Re: **Presidio Heights**

MDP # 003-07A

The City Staff Development Review Committee has reviewed Presidio Heights Master Development Plan **M.D.P. # 003-07A**. Please find enclosed a signed copy for your files. Your plan was approved for acceptance; however please note the following conditions:

PRESIDIO HEIGHTS MDP / PUD PLAN
 MASTER DEVELOPMENT PLAN / PLANNED UNIT DEVELOPMENT

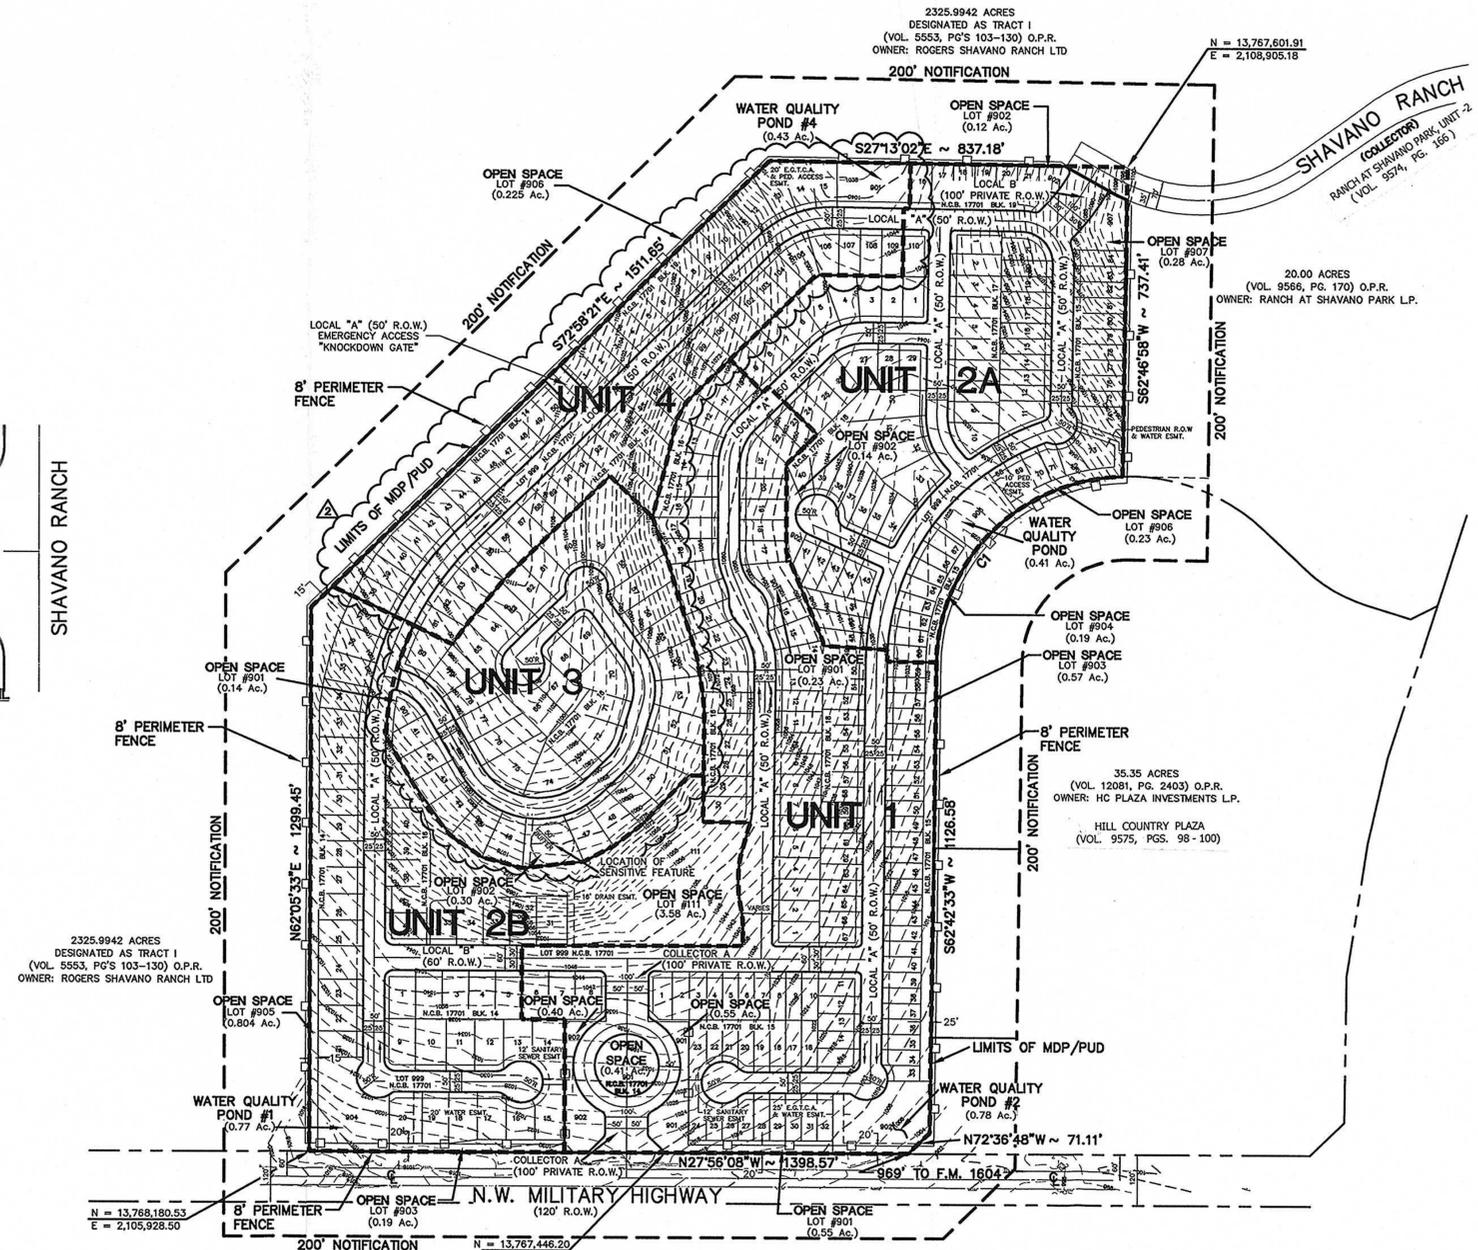
In consideration of public safety and convenience, excessive grades by reason of topography should be avoided in street layouts and arrangements. Any access and R.O.W. issues along state facilities will need to be resolved with the **Texas Department of Transportation (TXDOT)**. For information about these requirements you can contact TXDOT at 615-5814.

- All roadways shall conform to UDC 35-506(C)(1), Table 506-1: Functional Classification System Description.
- All access driveways shall comply with UDC 35-506(r) Access and Driveways.
- All access driveways shall provide clear sight distance on all existing and proposed roadways in order to provide adequate obstruction free viewing distances for approaching traffic. All signage, landscaping, and improvements shall be selected and located so as to not block these clear sight distances areas.
- The developer shall be responsible for providing right-turn deceleration lanes with storage lengths and bay taper in all the driveway access point approved by TXDOT as it relates to the submitted TIA traffic counts, Unified Development Code (UDC) – 35-502 (a)(7), subsection C.

- The parkland provided shall be shown as “Park” or “Open Space” on a plat; UDC section 35-503(e) *Designation of Parkland*.
- The parkland provided shall be dedicated to the Homeowners Association.
- The instruments creating the Homeowners Association shall be provided by the second application for plat approval; UDC section 35-503(e) *Designation of Parkland*
- Parkland dedication shall be platted by the second phase of development; UDC section 35-503(f) *Development Phasing*.
- All amenities provided shall comply with standards and specification found in UDC section 35-503(h) *Credit for Park Facilities* and Table 503-4 if any credit is to be awarded.

- This development will be allowed to pay the Storm Water Management Participation Fee. The provided Storm Water Management Plan shows the existing culverts on Military Hwy to be “safe” under ultimate conditions. Therefore, there is no need to upgrade the culverts as proposed and the request to provide offsite mitigation in lieu of paying the Storm Water Management Fee has been denied.

- Category Letter for All Site Specific Plats (If Category 2 or 3, an Aquifer Protection Plan is required (If applicable))
- According to the Aquifer Protection Ordinance No. 81491, section 34-913 buffering may be required. The sensitive feature found on property has been noted and SAWS is in agreement of the 4 acre buffer provided by the developer. Any existing well(s) found on site shall be plugged by the property owner in accordance with SAWS regulations. For plugging procedures please contact Kirk Nixon at 233-3523.
- Additionally, a Water Pollution Abatement Plan or Contributing Zone Plan must be submitted to and approved by the Texas Commission on Environmental Quality (TCEQ) prior to construction.

- The Ranch at Shavano Park Unit 2 plat # 050271 provides secondary access to this development, which needs to be recorded, constructed, and accepted by the City by or before the 125th lot is reached.
